Model 265RX

Bevel gear

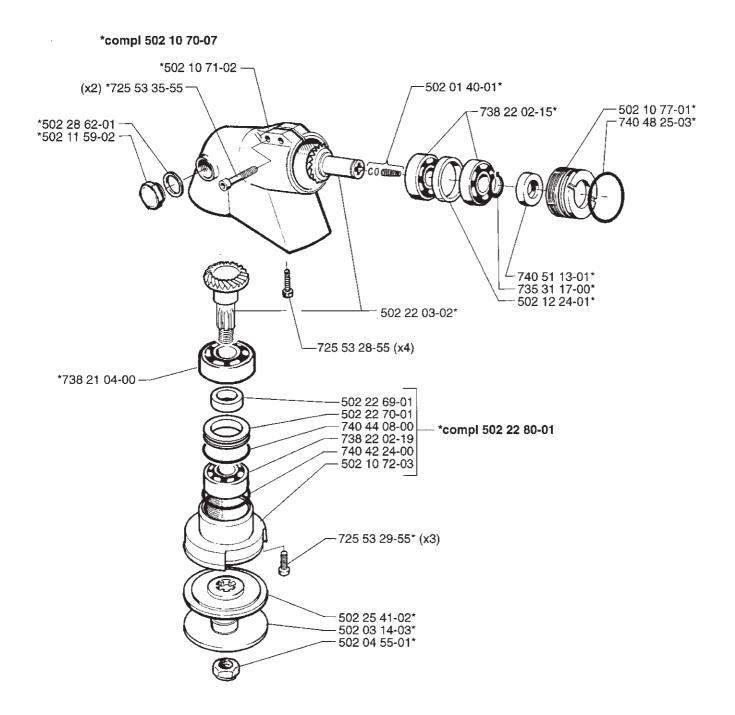
To reduce the working temperature the sealing ring has been removed. This has been replaced with a spacer ring, sealing collar and O-ring.

The cog set now has a new reference number because the blade shaft and cog have been modified. The modified gear housing cover, 502 22 80-01, only fits cog wheel set 502 22 03-02. The earlier version of gear housing cover, 502 10 69-03, only fits cog set 502 22 03-01.

Brought into production from serial number 6490191.
